KRAUS-ANDERSON® CONSTRUCTION COMPANY

ADDENDUM NO. 3

June 7, 2013

Duluth International Airport
New Parking Structure and Exterior Wayfinding Signage
Bid Package 2D
Duluth, MN 55811

5 SKYWALK SECTION DETAIL
1-1/2" = 1'-0"

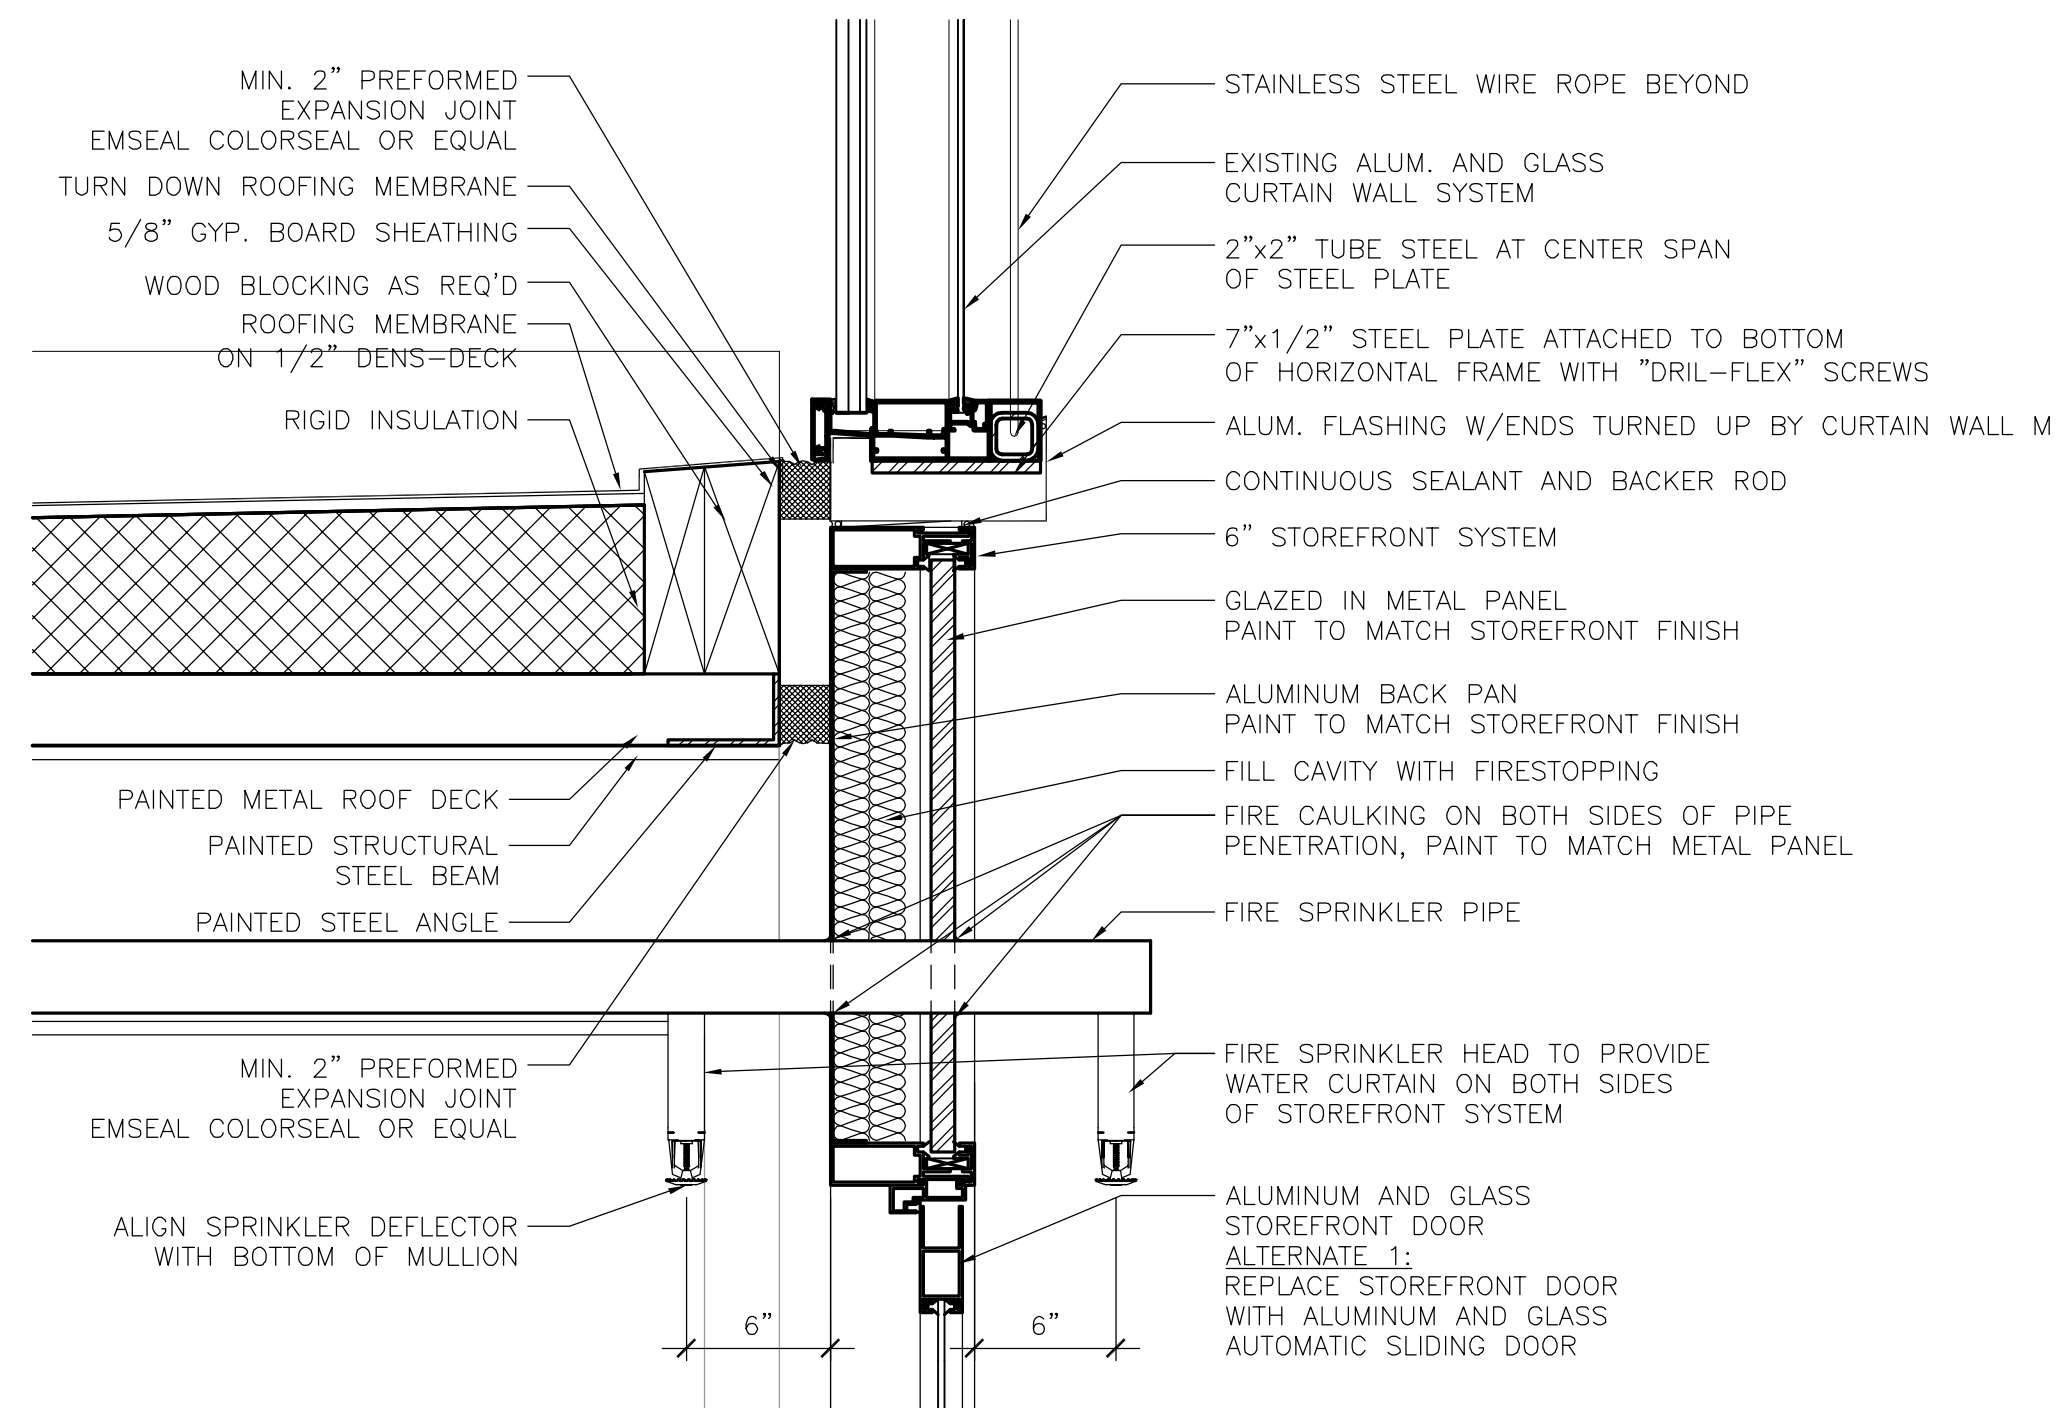
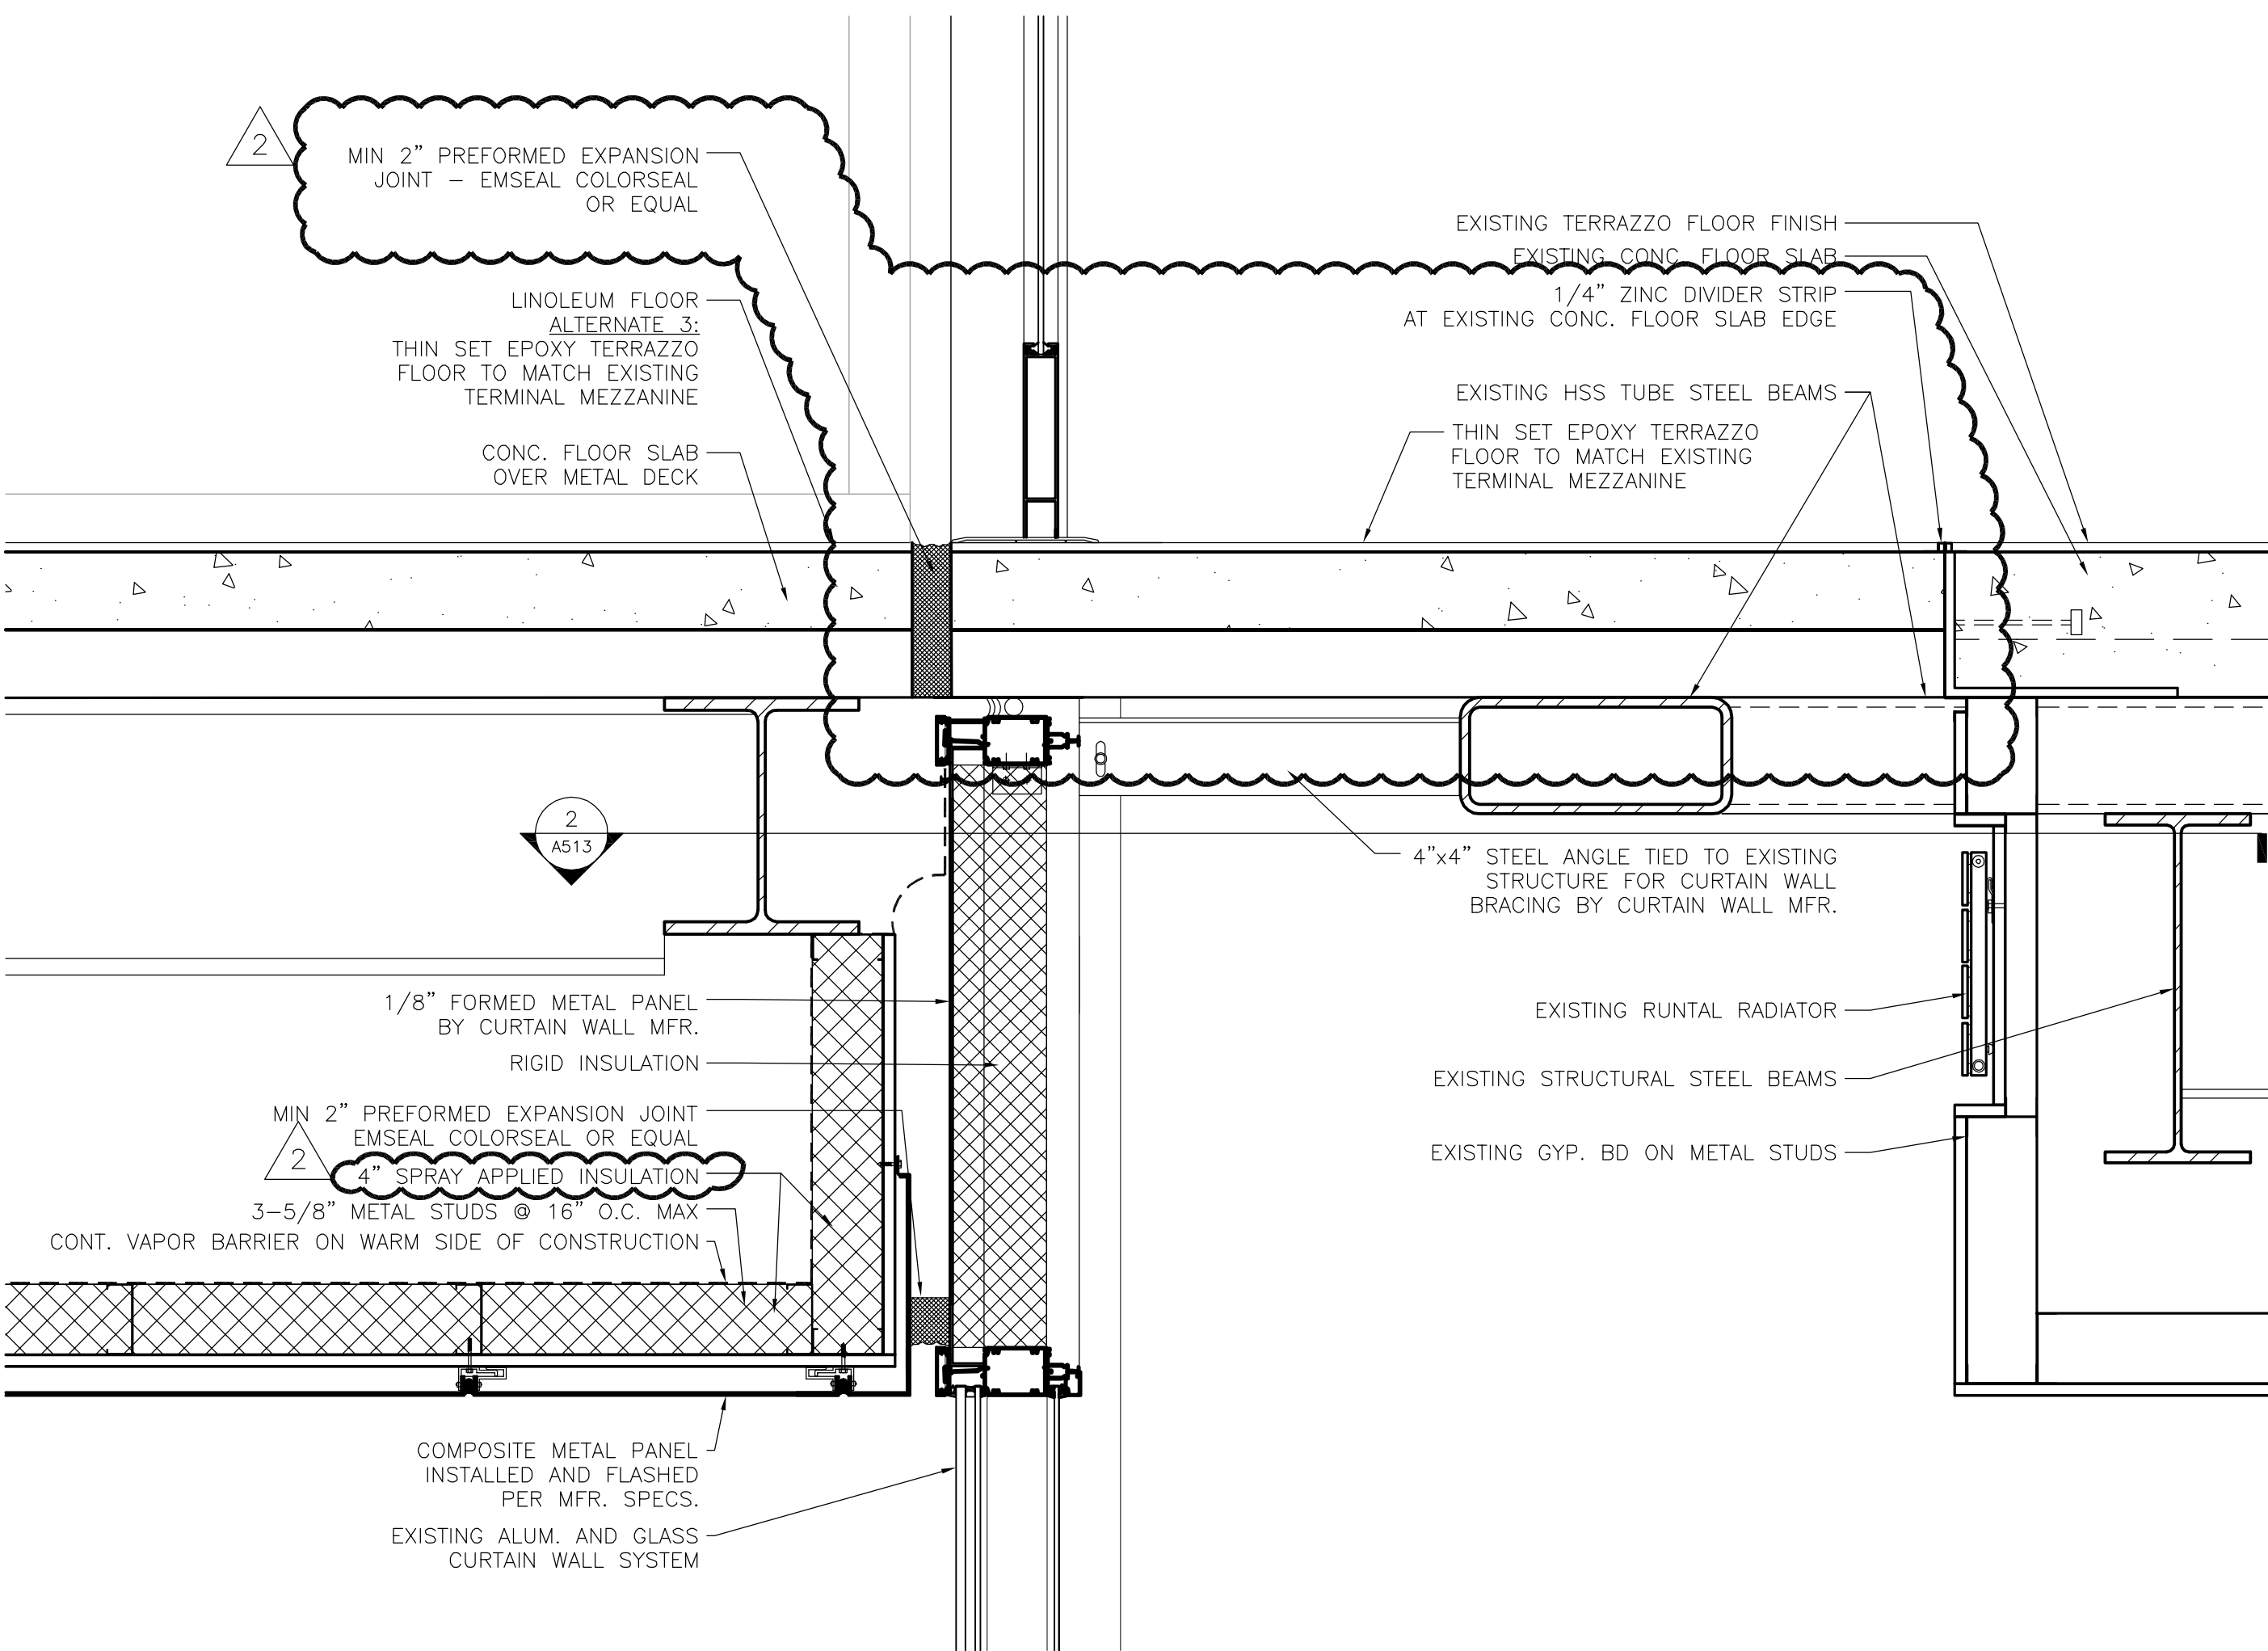
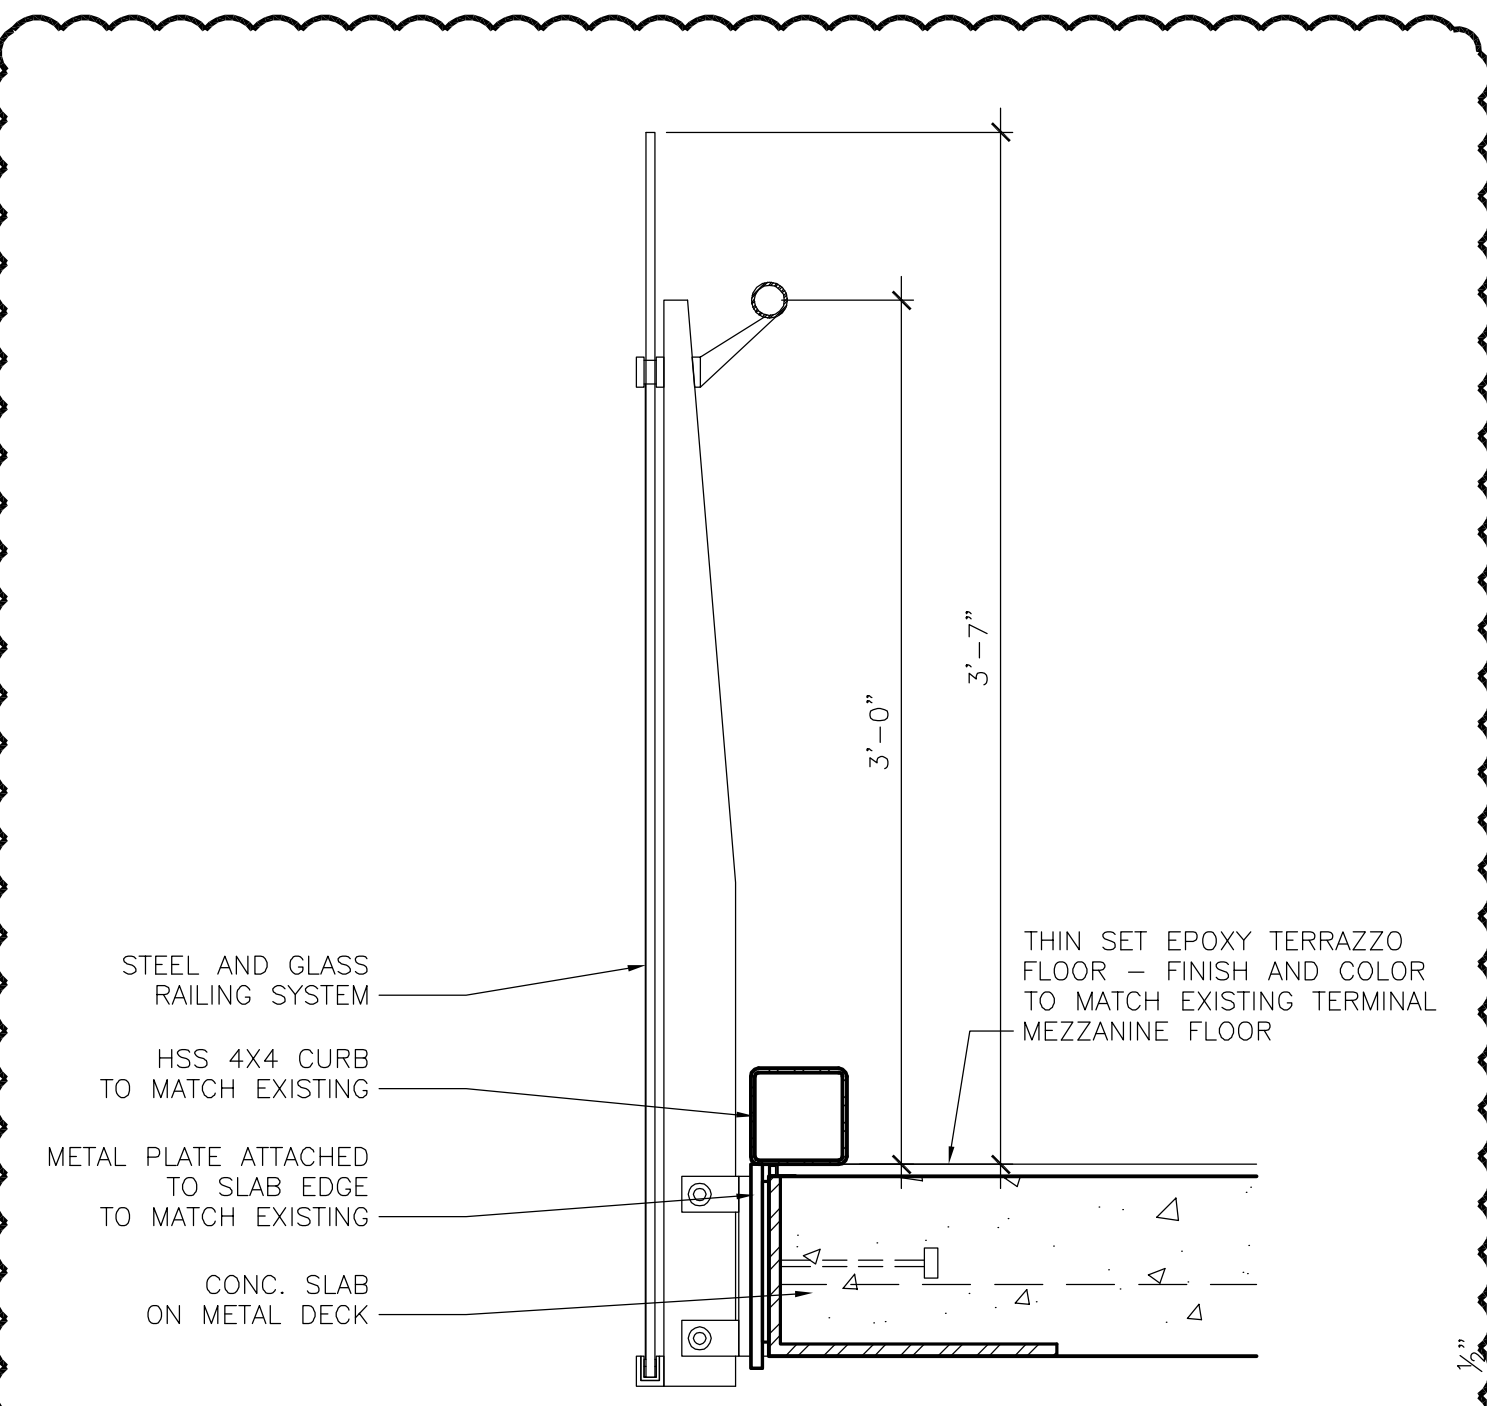
4.	WS 5.10D	Per the Work Scope 5.10D Item W, the architectural drawings do not have any detail that match the existing edge detail. I believe the architect should make a detail and add it to the bid documents.	Detail 6/A526 added to Addendum 3.
Sign Source, Inc.

6 SLAB EDGE DETAIL
1-1/2" = 1'-0"
